Palo Verde Nuclear Generating Station

102-05989-DCM/GAM
April 14, 2009

Subject: Palo Verde Nuclear Generating Station (PVNGS)
Units 1, 2 and 3
Docket Nos. STN 50-528, 50-529, and 50-530
Supplement 1 to License Renewal Application

Figure 4.5-2: Regression Analysis of Unit 1 Vertical Tendon Lift-off Data Through the 15-Year Surveillance; With Reg Guide 1.35.1 Predicted Prestress
(See Notes)

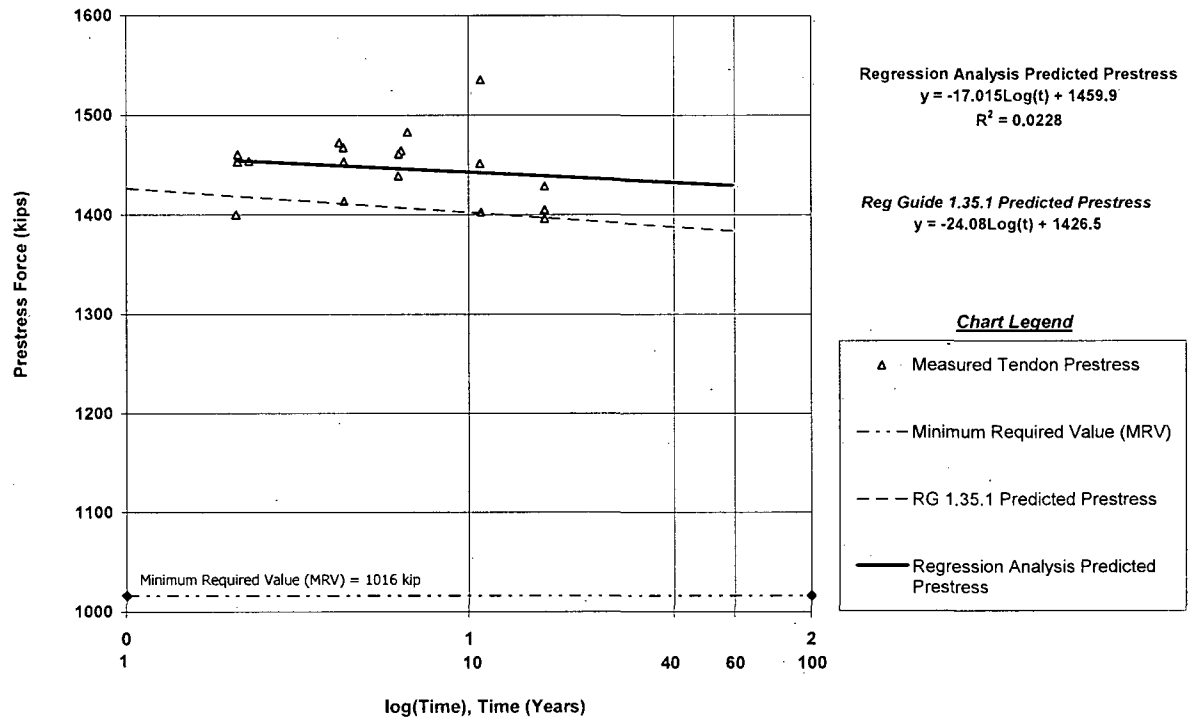
- Figure 4.5-2

Extended the Regulatory Guide 1.35.1 Predicted Prestress graph values to 60 years.
